# Technical Advisory Bulletin (TAB)

**Bulletin #:** TBMELCO12A

**Product:** Melco EMT16, BRAVO

**Subject:** New Control Board

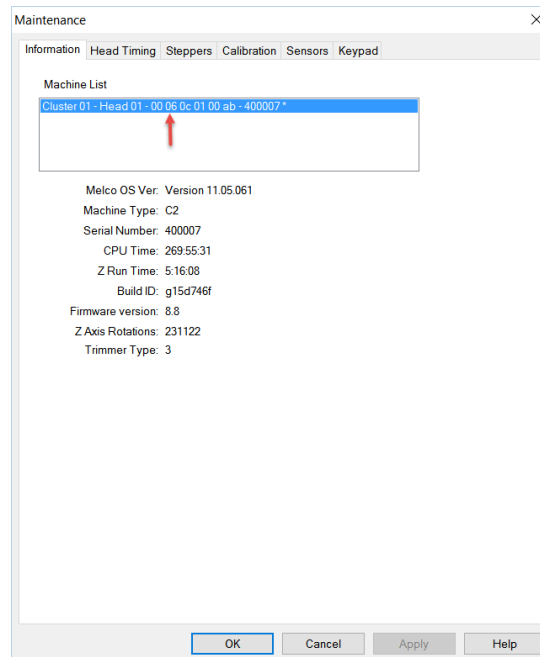
- 1) **Sewing Lights** stay on during E-Stop.
- 2) **Frame and Needle Case movements:** The previous Board would only do one function at a time while the new Control Board multi tasks. It will color change and move X and Y Axis at the same time.
- 3) During boot up the **boot sequence** is different. The new Control Board homes Needle Case and the X and Y Axis at the same time.
- 4) **Reset TBS** (Thread Break Sensor): New Control Board does not use the same MSP chip, hence there is no need for TBS reset. TBS is greyed out.

**Calibration window for TBS** has been hidden. This has been done due to the fact that factory calibration should be solid enough for the majority of the users.

#### To expose TBS calibration:

1. Computer\HKEY\_CURRENT-USER\SOFTWARE\Melco\MC\Settings
  2. Create a new DWORD (32-bit) Value
  3. Name = ShowTBS
  4. Value 1 = on
  5. Value 0 = off
- 5) **Homing Frame:** New Control Board homes both X and Y axes at the same time.
  - 6) **Trimming:** New Control Board has a slightly different behavior during the trim sequence. This is mainly due to the way all motors work with the new Control Board and how the new firmware processes all the steps involved. The difference is mostly in how quiet/smooth the grabber moves in and out.
